June 15, 2021

New York State Department of Environmental Conservation
Attn: Kristen Cady-Poulin, Environmental Analyst,
625 Broadway
Albany, NY 12233-1011

Re: Catalum SPDES No. NY026-4652 (NYSDEC Case No. D007-001-11.01)

Figure 14.2-1
Ashokan Reservoir Alternatives

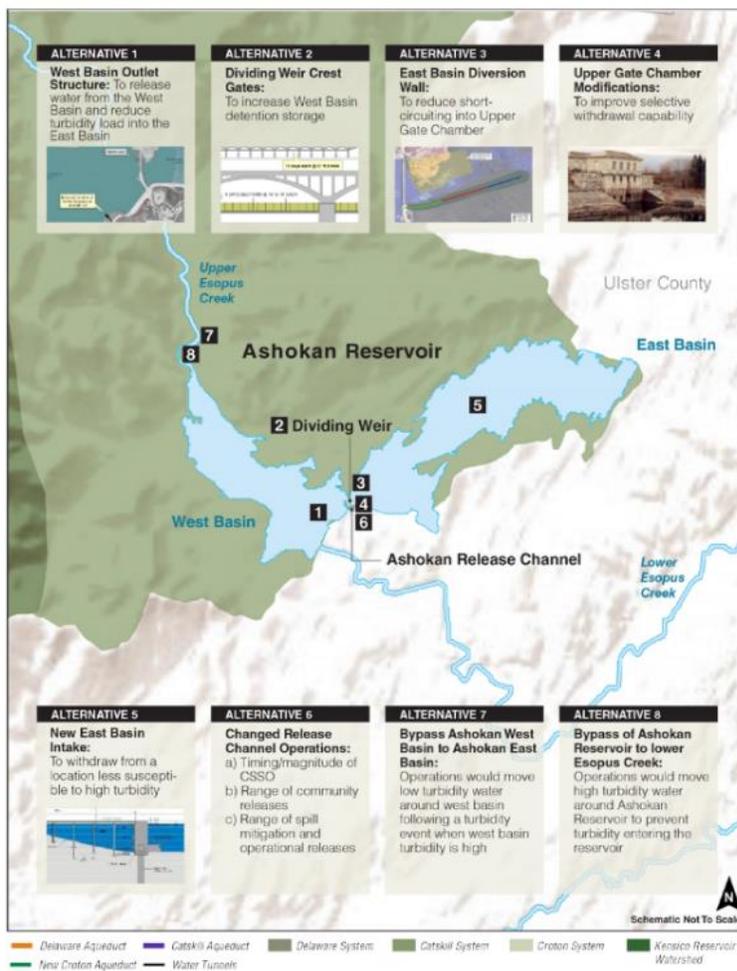
Before evaluating these alternatives, I want to discuss the DEP's overall approach. This section is not a typical alternative analysis that is presented in most engineering reports. This is only a presentation of alternatives to the alternative already selected by DEP. Alternative analyses should start with an open mind to all possible alternatives. Then, the benefits of these alternatives should be established by all stakeholders, not just the benefits to DEP. The capital and operations costs should be determined for each alternative. The DEIS does not present any costs for consideration except to say an alternative is too expensive. Once the cost and benefits are determined, a cost-benefit analysis should determine the alternative that provides the most benefits for money spent. In addition, alternative analyses should include detailed explanations and sketches of the alternatives. None of these steps were taken, and therefore, the alternative analysis is worthless.

In addition, the alternatives are not clearly explained for laypersons, and these explanations should be provided so that the public understands them. I prepared a detailed description of these alternatives with drawings in a memorandum to the concerned environmental groups. I spent many hours answering their questions and explaining the engineering aspects of each alternative. I found members of these groups to be very knowable and included scientists and biologists. However, there were no engineers in the groups to explain these alternatives. I learned that many engineers are unwilling to challenge DEP because of the engineering work that DEP can provide them. I hope this is not true, but my firm and I believe that it is our duty as professional engineers to assist all persons in developing a plan that satisfies all stakeholders. I also think that DEC's responsibility to work with these groups to provide

Fig. 7.7. Reservoir intake.

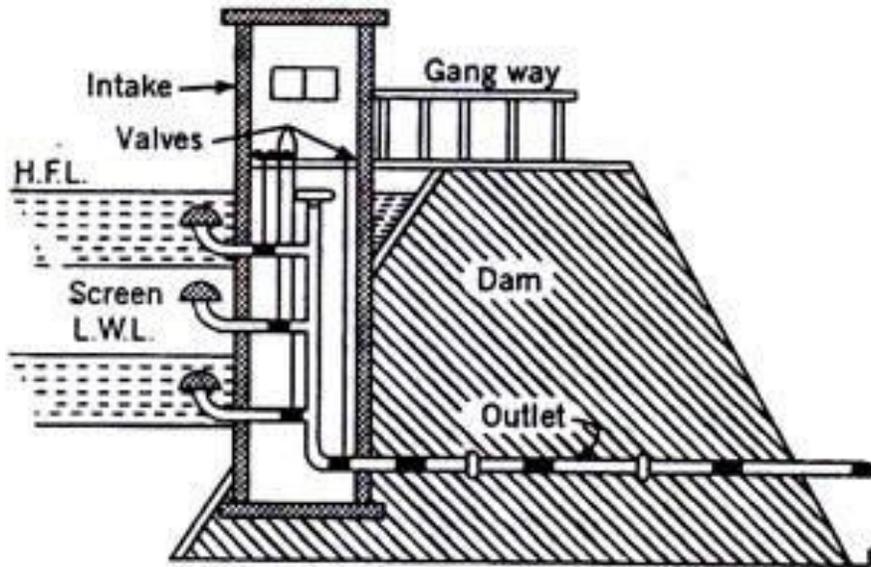
The water from the outlet pipe would be discharged to the Lower Esopus Creek. DEP proposes to design the structure to handle up to 6,000 MGD, which would flood the Lower Esopus. It should be designed for no more than 600 MGD, which is the current limit. This alternative will make the discharge even worse since the intake structure will be closer to the Upper Esopus discharge, lessening the retention time, increasing the turbidity, and possibly creating short-circuiting. In addition, the conduit to carry 6,000 MGD would be tremendous and cost-prohibitive. To carry only 600 MGD, the conduit would have to be approximately two 12' x 12' culverts, as shown below. DEP decided not to pursue this alternative, and I agree.

Inflatable Crest Gate

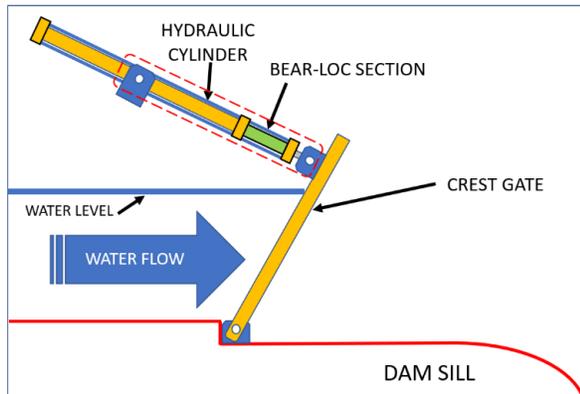
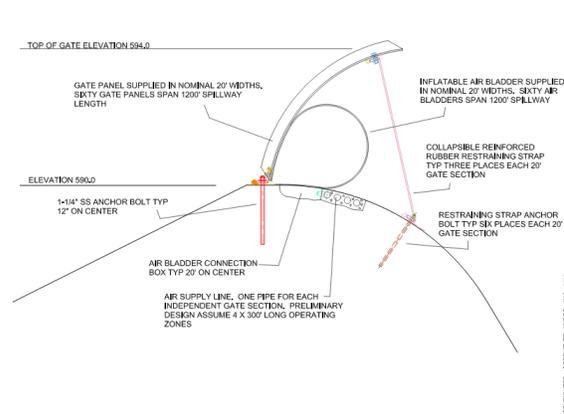
Obviously, the inflatable dam will be less expensive than the inflatable crest gate and crest gates, but the crest gate would make it easier to change the elevation of the West Basin. The crest gate can raise and lower the reservoir by rotating the crest gate. The inflatable dam may be an excellent temporary solution since it can be installed quickly but will deteriorate in the sunlight.

All these options will raise the West Basin by four feet but could flood the West Basin's surrounding area. By lowering the West Basin to the existing weir height to remove water and then raising the dam or gate, four feet will allow a storage volume of 3-4 billion gallons during a storm event. According to historical flow records for Coldbrook, the peak flows are approximately 10 billion gallons. For the Christmas Storm of 2020, the flow over four days was 17.9 billion gallons. Although the dam or crest gate would have only captured 17-22 percent of a Christmas Storm event and only capture 30-40% of a peak historical storm, it will probably catch most of the turbidity, which occurs mainly at the start of the storm. To capture the additional flow, DEP should start to release a maximum flow without flooding the downstream communities as soon as the flow at Coldbrook Station reaches 2,000 MGD or before a predicted significant storm. DEP could also maintain the level in the West Basin below the weir wall. During the Christmas Storm of 2020, the flow peaked on the 25th, but DEP did not release water to the waste channel until the 29th. This delay was probably because the stop shutters could not be removed manually fast enough or the flows from Sawkill and Plattekill were too high to release water from the Ashokan. I would suggest that modeling be performed to determine the flow amount for releases during a significant storm event to prevent flooding and minimize turbidity.

I contacted Obermeyer Hydro, Inc to obtain prices for the inflatable dam and inflatable crest gate. The firm's vice president informed me that he gave a proposal and the above drawing of the inflatable Crest Gate to DEP in 2007. He also gave me the cost of \$3,887,000 for an inflatable dam and \$5,398,000 for inflatable crest gates. I compared these costs with the costs in the Value Engineering Study dated January 2008. Inflating the VE cost to 2021, the estimated cost is \$161,744,000, which is nearly 30 times the estimated cost for inflatable crest gates. It may be that DEP's estimate is based on hydraulic-operated crest gates. I believe that inflatable gates should be adequate, at least for a temporary measure.

Figure 14.2-2
Existing East Basin Dividing Weir and Diversion Wall
(Red lines show short-circuiting of flows over existing diversion wall)

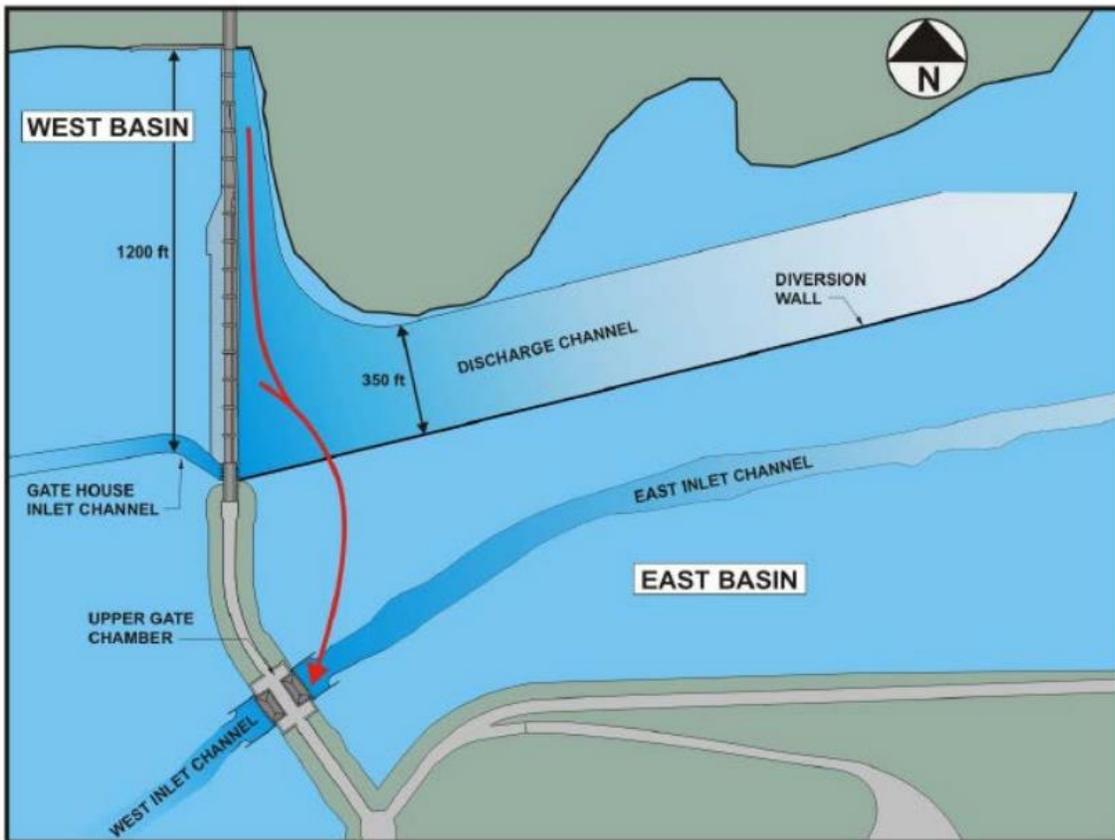
When the reservoir is full, the Diversion Wall is 20 feet below the water surface. The submergence allows short-circuiting to the East Basin Intake Chamber, as shown on the picture and drawing below with red lines indicating the short-circuiting:

In April 2021, I visited the Dividing Weir and witnessed the short-circuiting, as shown below. At the west end of the East Basin, the water was turbid, but the water was clear at the east portion of the East Basin.

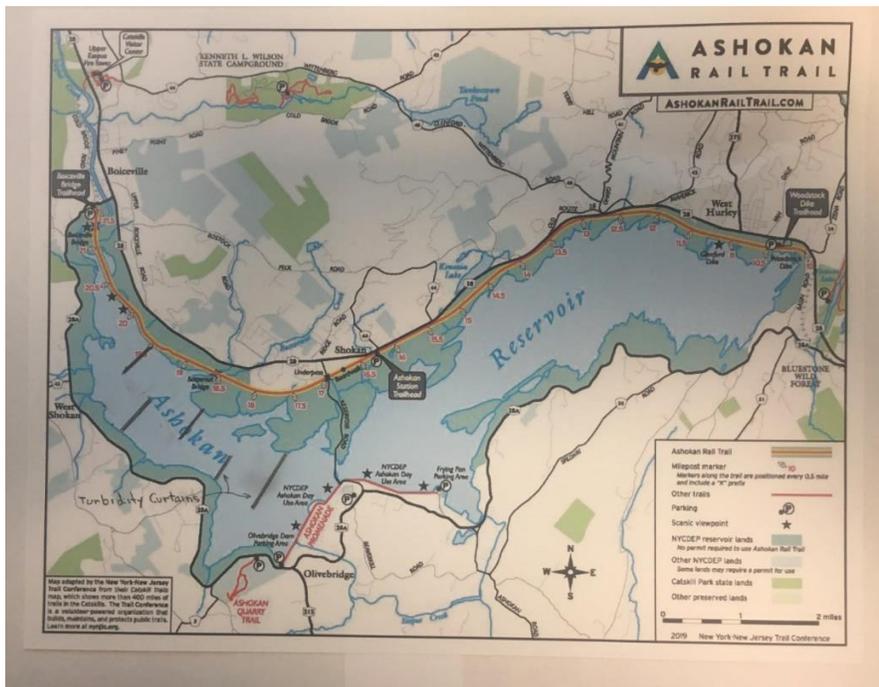
Per the modeling done for DEIS, the modifications to the diversion wall would reduce the turbidity in proportion to the wall's length but would have limited benefits for extended periods of high turbidity.

I like this alternative, but I suggest using a turbidity curtain above the wall and extending the turbidity curtain to a length that would reduce turbidities even during extended periods of high turbidity. According to manufacturers, these curtains could be installed quickly before next spring at the cost of approximately \$400,000 for the curtain that would extend 3,000 ft into the East Basin. In contrast, a 2,400-ft jetty wall or cofferdam cost about \$998,378,000 or \$351,175,000, respectively, based on the 2008 Value Engineering Study, inflated to 2021. The curtain could be extended to the Glenford Dike at the far east end of the East Basin at a cost lower than 2,400 feet of a cofferdam. One manufacturer to whom I spoke is working with DEP to supply a barrier in the Kensico Reservoir. A picture of a turbidity curtain is shown below:

Figure 1-9. Stop Shutter Schematic

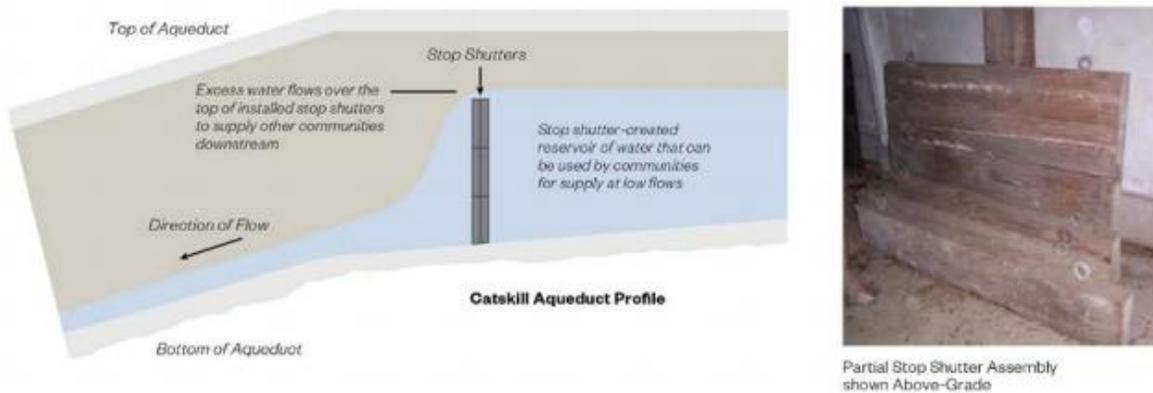
The operation of the stop shutter is challenging to change water levels since each stop shutter must be lifted out or in to change levels. Today, water systems use stop logs constructed of steel and can be lifted in and out with a crane, as shown in the pictures below.

DEP is proposing an improved multi-level intake and may include these intakes in the Ashokan Improvement Project. However, in the DEIS, it is indicated proposed intakes would only provide a limited turbidity reduction. I would recommend replacing the labor-intensive and dangerous stop shutters with steel stop logs and motor-operated hoist and moveable frame

Plate Settlers

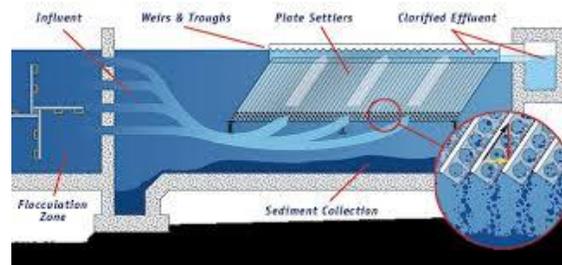
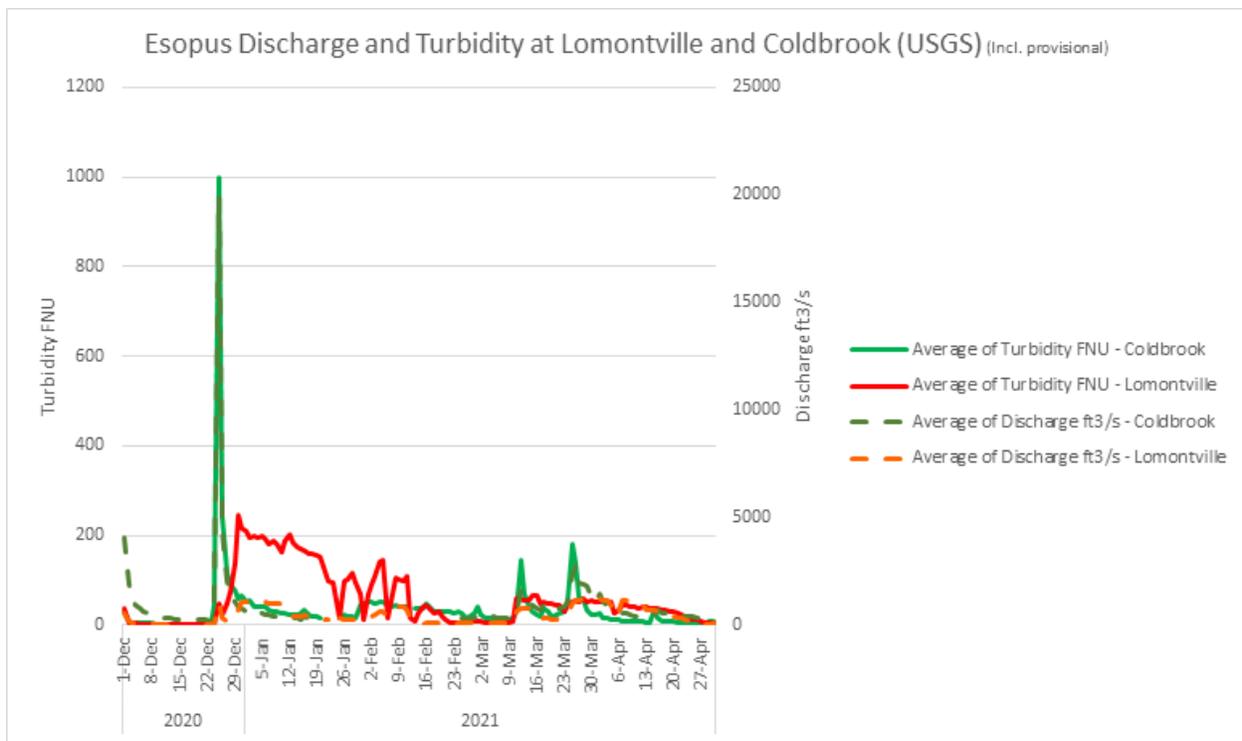
Because of a peak flow of 12,900 MGD (Peak flow during the 2020 Christmas Storm), the tube settler area would be 3,600,000 square feet. The installed tubes would cost about \$1,000,000,000 and would require a massive structure to hold them in place. The support structure may double the price. If effluent turbidity requirements could be increased at the peak flow and the tubes sized for the average flow of 575 MGD (Average flow from December 1, 2020, to April 30, 2021), 160,000 sq. ft. would be required, and the installed cost would be \$4,480,000. However, the support system may double the price. Life expectancy for tubes installed outdoors is about 10 years; 15 years maximum outdoors when considering UV degradation.

The plate settlers would have a longer life of 50 years and require less area than the tube settlers. However, they would cost more. To size for peak flow, the cost would be \$1,550 million. If sized for the average flow, the cost would be \$34.5 million. As with the tube settlers, the price could double because of the support structure needed.

1. What is the cross-section of the dividing wall?
2. What is the water depth in the proposed area 1,000' out from the 1,200' long dividing weir? Is bedrock available in this area?
3. Is it cost-effective to build concrete structures west of the dividing wall to support plate beams and cross-collection flumes?
4. Is there any jar testing data or water characterization on the fine clay high turbidity events to determine the most cost-effective loading rate to achieve target effluent turbidities?
